**Request for Construction Change
Summary Change Order No. 3**

Contract No. 2014-0037
Project Third Avenue North Trail
PIN 109424.00
Fed. Proj. No. STP-M-9305(28)

**Supplemental Agreement and/or Request for Construction Change
 Change Order Request # Z**

Project Title/Termini:	<u>City of Franklin - 3rd Avenue North Trail/Greenway</u>		
Owner:	<u>City of Franklin</u>	PIN:	<u>109424.00</u>
Address:	<u>109 3rd Avenue South</u>	State Project No.:	<u>94LPLM-F3-018</u>
	<u>Franklin, TN 37064</u>	Federal Project No.:	<u>STP-M-9305(28)</u>
Date Prepared:	<u>11/3/2016</u>	Contract No.:	<u>2014-0037</u>
		County:	<u>WILLIAMSON</u>

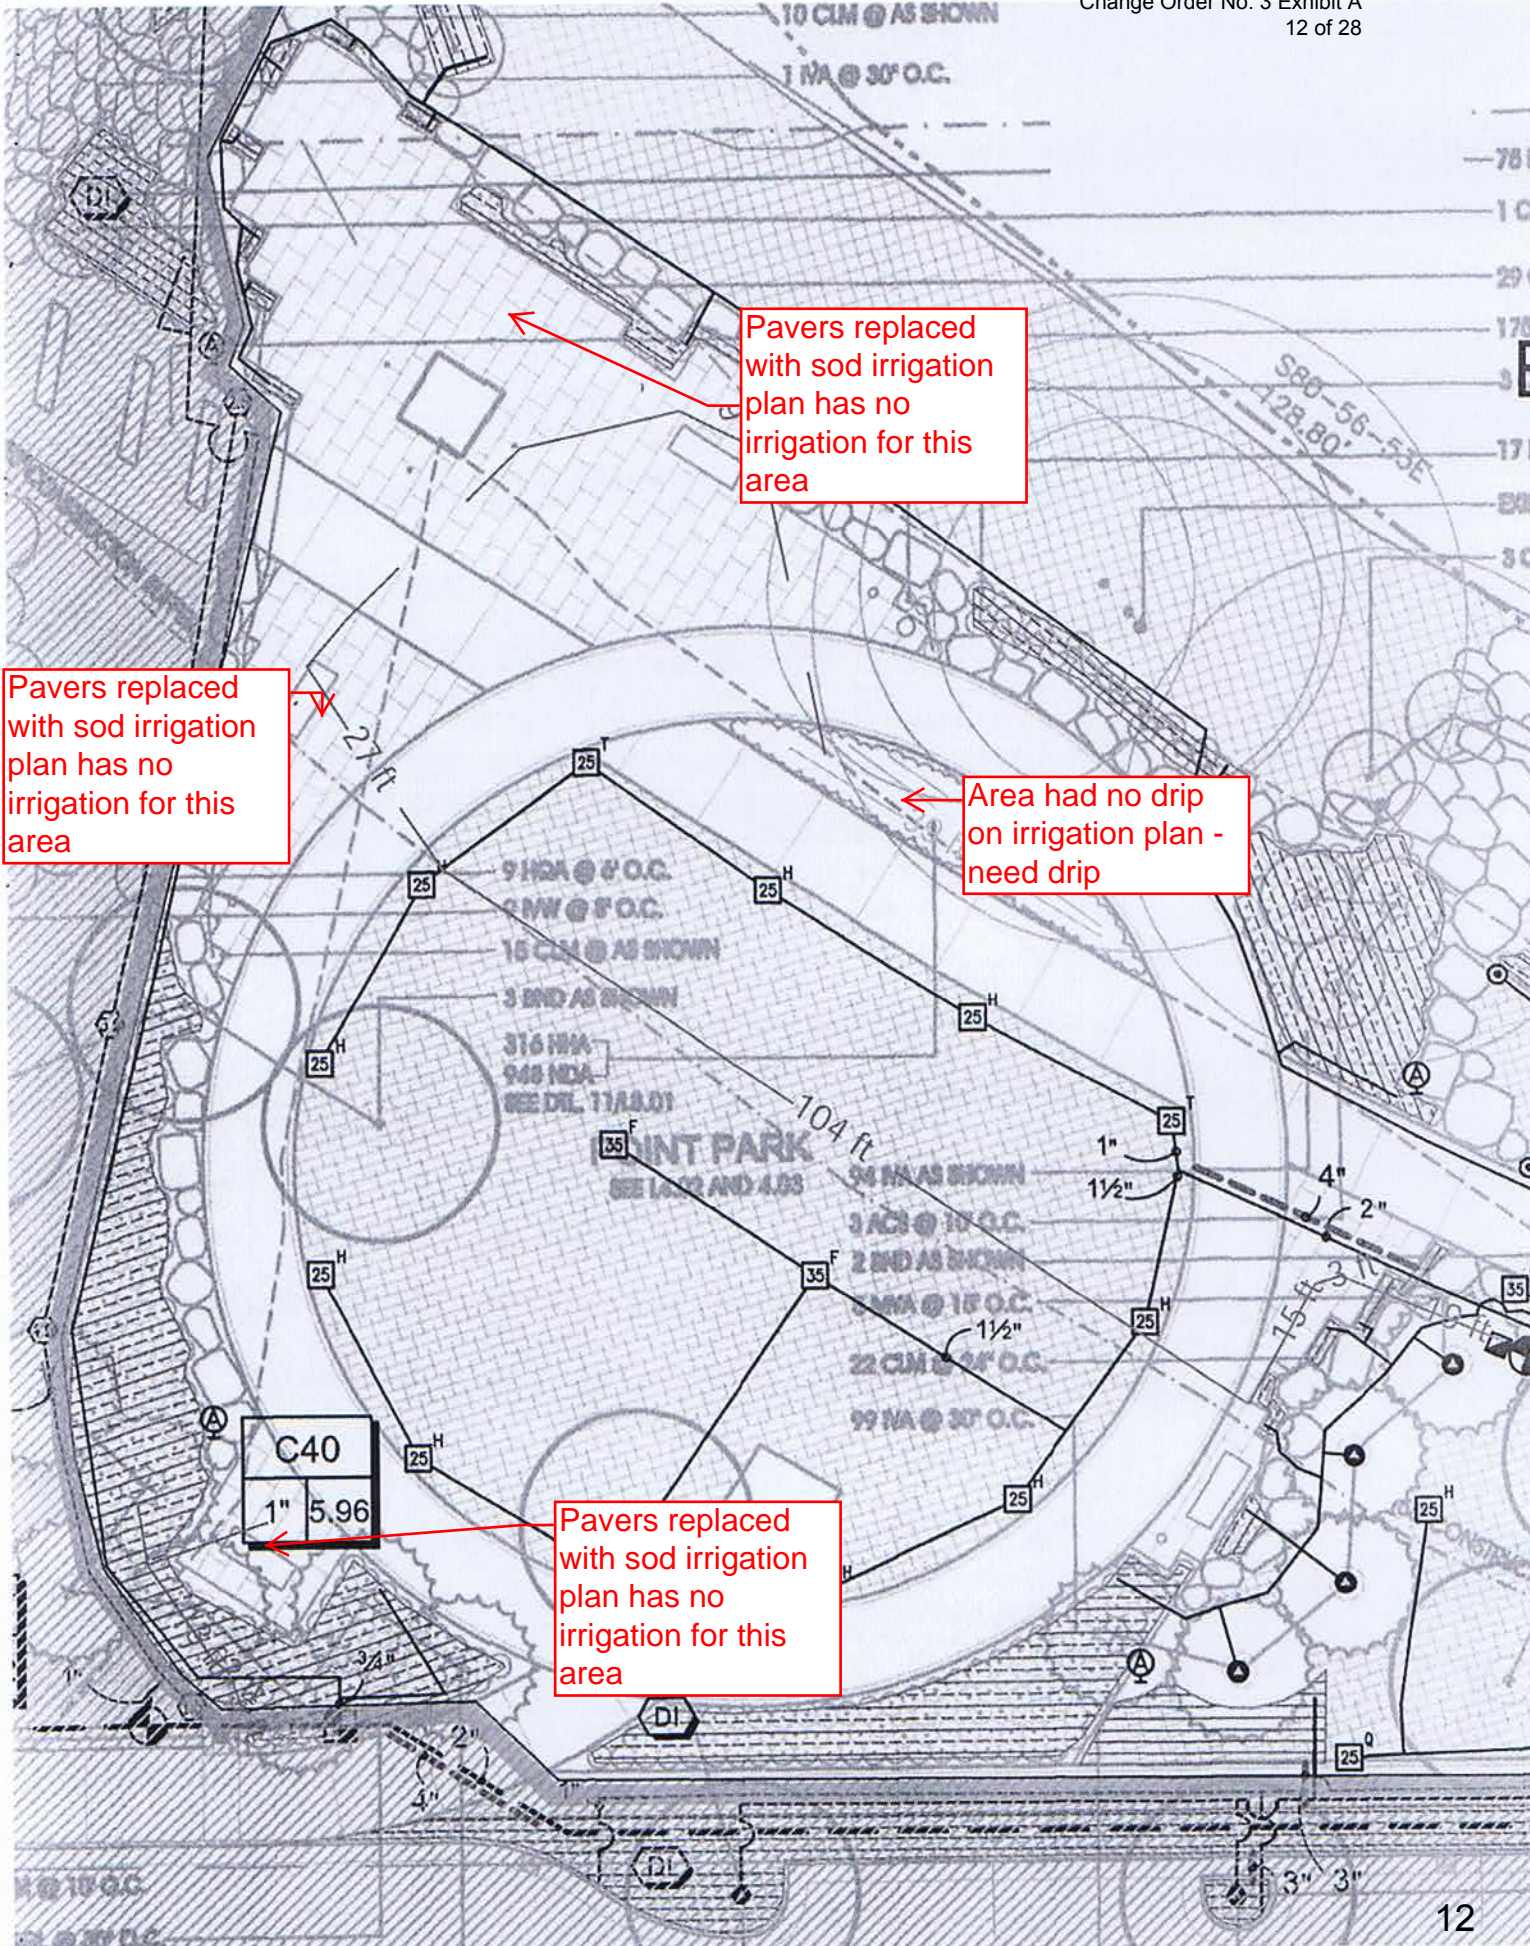
Pavers replaced with sod irrigation plan has no irrigation for this area

Pavers replaced with sod irrigation plan has no irrigation for this area

Area had no drip on irrigation plan - need drip

Pavers replaced with sod irrigation plan has no irrigation for this area

Jones Bros. Contractors, LLC (“JBC”) respectfully submits the pricing below* to incorporate the additional irrigation requirements requested by the owner.

*Pricing qualifications: Sawcutting of the concrete trail is required to service the new irrigation areas. Additional irrigation will be paid by over-running existing pay items. Subcontractor bond is not included in the itemized prices that will over-run. An additional change order will be required to reconcile the subcontractor bond costs for the additional work requested by the owner. Additional days are required for the additional irrigation work.

ITEM	DESCRIPTION	QUANTITY	UNIT	UNIT PRICE	Additional Time Required
502-04.01	Sawcutting irrigation trench across 10' concrete trails for new irrigation lines	1.0	EACH	\$ 525.00	3-Days
